North – South Commuter Railway (NSCR) Project (Malolos – Tutuban) Package CP01: Elevated Structures, 7 Stations and Depot			
ITEM NO.	REFERENCE CLAUSE/ SECTION	CLARIFICATION REQUEST	RESPONSE
<i>Volume I, Part 1 – Bidding Procedures</i>			
1	Page BDS-3, ITB 14.7	The present text states that “In connection with such tax assumption ”. Is it the same meaning as “In connection with such tax exemption ”?	No, “tax assumption” implies that the obligation or liability remains, and is merely passed on to a different entity. On the other hand, “tax exemption” implies freedom from a duty, liability or other requirement, or a privilege given to a judgment debtor by law, allowing the retention of certain property without liability. “Tax assumption” is a stronger declaration by the Employer as it indicates, in the event another government agency insists the Contractor pay a certain tax, the Employer assumes the responsibility for payment of such tax. In the case of Value-Added Tax (VAT), the Contractor will pay the tax which will be passed on and assumed by the Employer. Therefore, the Contractor is not exempted from paying VAT.

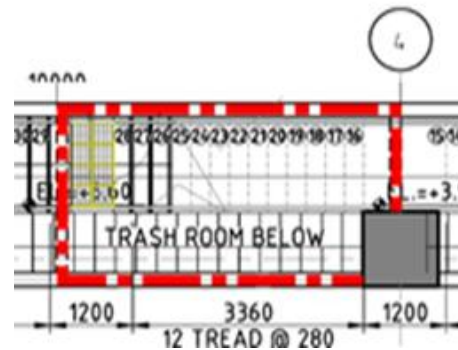
Floor Plan	Louver Schedule	Louver Figure	L2A	☉20	14	14	L2B	☉36	26	26	L3O	☉2	2	7	L3P	☉2	2	7	L4B	☉2	1	2	L4C	☉1	1	2	L4E	☉22	25	25	<p>Yes, the Bidder's assumption is correct.</p> <p>Floor Plan</p> <p>L2A ☉20</p> <p>L2B ☉36</p> <p>L3O ☉2</p> <p>L3P ☉2</p> <p>L4B ☉2</p> <p>L4C ☉1</p> <p>L4E ☉22</p>
	Floor Plan	Louver Schedule	Louver Figure																																
L2A	☉20	14	14																																
L2B	☉36	26	26																																
L3O	☉2	2	7																																
L3P	☉2	2	7																																
L4B	☉2	1	2																																
L4C	☉1	1	2																																
L4E	☉22	25	25																																
19	Book 6 of 11, Page CP01-B6-020	On CP01-B6-020, Expansion Joint is indicated on Grid 6 and 12, but on page CP01-B6-112 <SECTION 2P>, it is indicated as Roof Gutter. May we assume that Expansion Joint Cover for Roof is unnecessary?	Yes, the Bidder's assumption is correct.																																
20	Book 6 of 11, Page CP01-B6-018, 025	<p>At Ground Level (Grid 18 to 19/A and D), the existence of CYCLONE WIRE FENCE differs as follows,</p> <p style="margin-left: 40px;">CP01-B6-018 ··· Existent</p> <p style="margin-left: 40px;">CP01-B6-025 ··· Non-Existent</p> <p>May we assume the one indicated on CP01-B6-025, Non-Existent to be correct?</p>	Please follow the drawing in Book 6 of 11, Page CP01-B6-018 which indicates Existent.																																
21	Book 6 of 11, Page CP01-B6-019,	At Concourse Level Sta. Staff Room and Pantry (Grid 14-15/D), Window call-out differs as follows,	Yes, the drawings in Book 6 of 11, Pages CP01-B6-019 and CP01-B6-025 are correct.

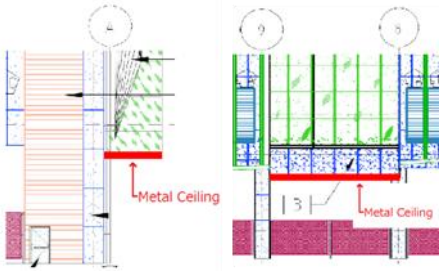
26	Book 6 of 11, Pages CP01-B6-024, 028, 038, 062, 069, 070	At Concourse Level Ceiling Height differs for the different plans indicated below. May we assume the one marked with © to be correct? < Cleaner’s Room > CP01-B6-028,038: CH=2700mm © CP01-B6-024: CH=3000 < AFC Room > CP01-B6-028,038: CH=3000mm © CP01-B6-069: CH=5876mm	Yes, the Bidder’s assumption is correct.

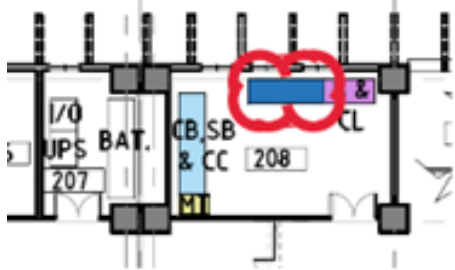
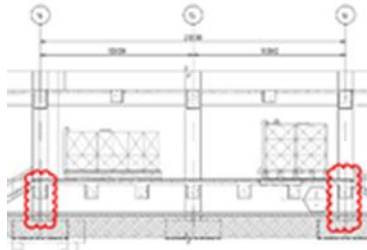
28	Book 6 of 11, Pages CP01-B6-038, 099	At Concourse Level PWD Toilet 1 and 2, Floor finish differs as follows, CP01-B6-038	Yes, the Bidder's assumption is correct. Please use 600 x 600mm Vitrified Ceramic Floor Tiles and adopt the same for all stations.

ITEM NO.	REFERENCE CLAUSE/ SECTION	CLARIFICATION REQUEST	RESPONSE
		 <p>CP01-B6-135, 141 ··· with RC Wall</p> <p>CP01-B6-135</p>  <p>CP01-B6-141</p>

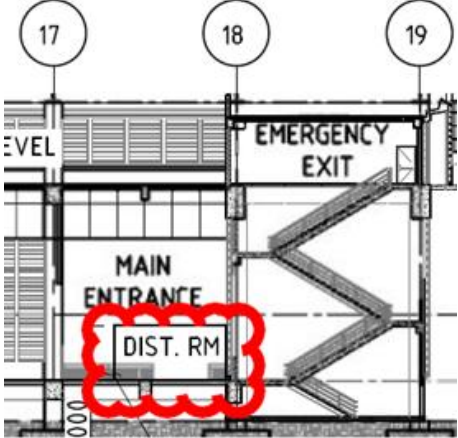
40	Book 6 of 11, Page CP01-B6-086	On CP01-B6-086, details of single and double gate are shown. Please specify their respective construction range.	Please disregard single gate. Assume 3 sets of double gate shall be used.
41	Book 6 of 11, Page CP01-B6-105	On CP01-B6-105, please provide the construction range of Expansion joint on Exterior Wall and Eaves (SST) 1-H Fire Resistant.	Expansion Joint runs thru the Floor, Wall and Ceiling.
42	Book 6 of 11, Pages CP01-B6-103, 135	At Ground Level, the exterior wall along grid 14 to 16/A to B differs as follows, CP01-B6-103 ··· Open <SECTION 1>  <SECTION 2>	Yes, the drawings in Book 6 of 11, Pages CP01-B6-135 and CP01-B6-141 are correct.

North – South Commuter Railway (NSCR) Project (Malolos – Tutuban) Package CP01: Elevated Structures, 7 Stations and Depot									
ITEM NO.	REFERENCE CLAUSE/ SECTION	CLARIFICATION REQUEST	RESPONSE						
		May we assume pages CP01-B6-135 and 141 to be correct?							
43	Book 6 of 11, PageCP01-B6-538	<p>For the rooms listed below, may we assume their respective finishes to be the following?</p> <p>< Trash Room (Grid 18/D)> Floor: 900 x 900 mm Non-Skid Granite & 300 x 300mm Granite Floor Tile (Accent) with Polyurethane Liquid Applied Membrane Waterproofing Skirting: 100mm High Paint Strip Wall: Semi-Gloss Latex Paint Finish Ceiling: Painted Soffit of Slab/Beam</p> <p>< PWD Toilets 1 and 2 (Grid 7/B-C)> Wall: 300 x 600mm Glazed Ceramic Tile Ceiling: 12mm thk. Moisture Resistant Gypsum Board on Metal Frames; Painted Finish</p> <p><First Aid Room (Grid 6/A-B)> Floor: 900 x 900 mm Non-Skid Granite & 300 x 300mm Granite Floor Tile (Accent) with Polyurethane Liquid Applied Membrane Waterproofing Skirting: 100mm High Vinyl Baseboard Strip Wall: Semi-Gloss Latex Paint Finish</p>	<p>The following are the respective finishes:</p>

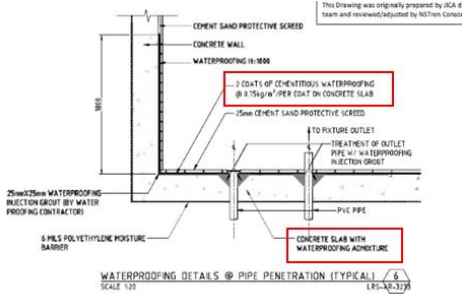
60	Book 6 of 11, Page CP01-B6-561, 562	At Schedule of Louver, Height of L3F differs as follows, CP01-B6-561 ··· H=11430 CP01-B6-562 ··· H=7535 May we assume the one indicated on CP01-B6-561, H=11430 to be correct?	Yes, the Bidder's assumption is correct.
61	Book 6 of 11, Pages CP01-B6-564, 570	On CP01-B6-564, Wall Mounted Sign (WS1-06) is indicated at Concourse Level (Grid 1-2/B), but is not found on CP01-B6-570 Schedule of Signage Graphics and Wayfinding Devices Sheet. Please provide the specification and detail of Wall Mounted Sign (WS1-06).	Please disregard WS1-06.
62	Book 6 of 1,	The Height of the Parapet Wall on Emergency Exit	The drawing Book 6 of 11 Page CP01-B6-579 <SECTION 2> and

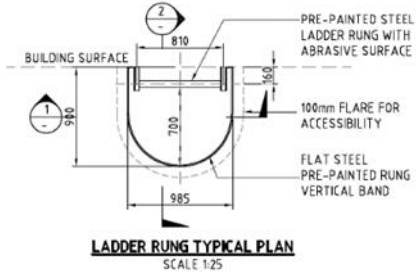
67	Book 6 of 11, Page CP01-B6-582, 621	<p>The existence of ACP/ACM on top of parapet wall differs as follows,</p> <p>CP01-B6-582 <SECTION 1> . . . Non-Existent</p> <p>CP01-B6-621 <DETAIL A> . . . Existent</p> <p>May we assume the one indicated on CP01-B6-621 <DETAIL A>, Existent to be correct?</p>	<p>Please follow the drawing in Book 6 of 11, Page CP01-B6-582 which indicates <SECTION1>, Non-Existent.</p>
68	Book 6 of 11,	The existence of Safety Rail @ Bottom of Ramp differs	Yes, the Bidder's assumption is correct. Safety Rail @ Bottom of

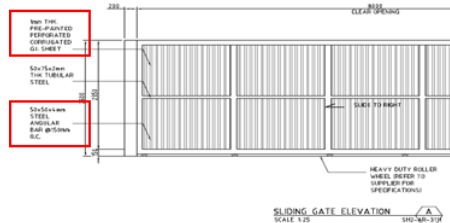
North – South Commuter Railway (NSCR) Project (Malolos – Tutuban) Package CP01: Elevated Structures, 7 Stations and Depot			
ITEM NO.	REFERENCE CLAUSE/ SECTION	CLARIFICATION REQUEST	RESPONSE
85	Page CP01-B9-198	<p><u>Reference:</u> (Hazardous Store) Fire alarm</p> <p>Outgoing cable from FACP is indicated "From FACP in OCC" Is this out of CP01 scope? If answer is NO, please provide design DWG (cable size cable support, routing)</p>	<p>Yes, it is not within the Scope of Work of the CP01 Contractor. However, necessary interface shall be carried out with the interfacing Contractors as per GS 100 Clause 126 and Appendix 4.</p>
86	Pages CP01-B9-251 & BOQ	<p><u>Wall Finish</u></p> <p>Please specify wall finish for Workshop Garbage Shed: - as per Schedule of finishes, it is Plain Cement while - as per BOQ, it is High-performance Urethane Coatings (Masonry Painting).</p>	<p>Please consider using High-performance Urethane Coatings (Masonry Painting).</p>
